AMENDMENT NO. 4 FEBRUARY 2026
TO
IS 15796 : 2008 AUTOMOTIVE VEHICLES AND AGRICULTURAL
TRACTORS — HORN INSTALLATION REQUIREMENTS

FIG. 1 MICROPHONE POSITIONS FOR MEASUREMENTS OF HORN SOUND PRESSURE LEVEL OF MOTOR VEHICLES'

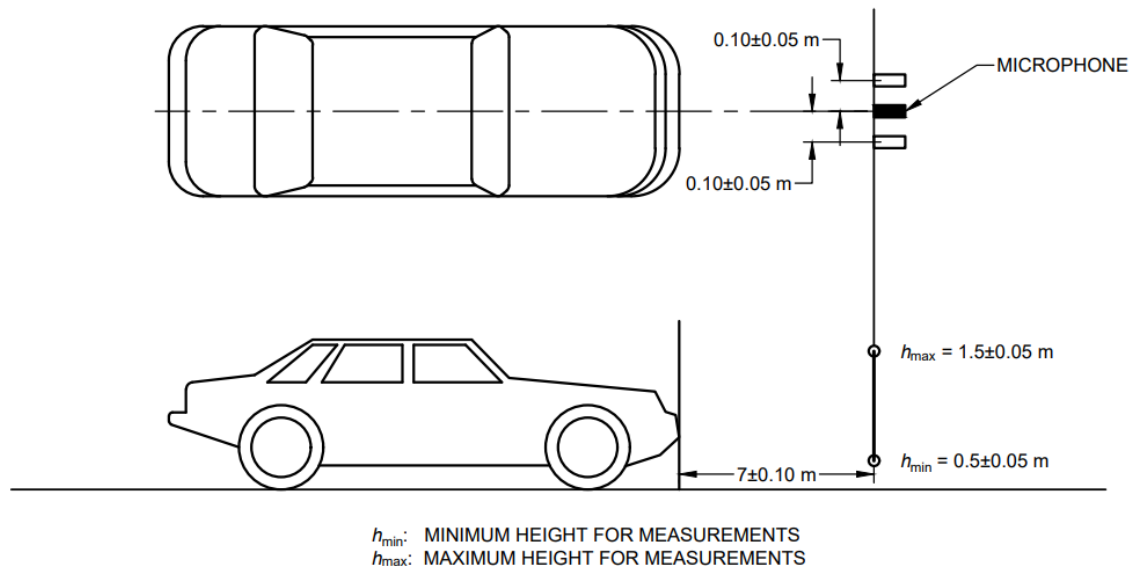
(Page 2, clause 6.2.4) — Substitute the following for existing:

‘6.2.4 The A-weighted sound pressure level emitted by the horn fitted on the vehicle shall be measured at a distance of 7.00 m $\pm$ 0.10 m in front of the vehicle, which is being placed on an open site (see Fig. 1), on flat concrete or asphalt surface.
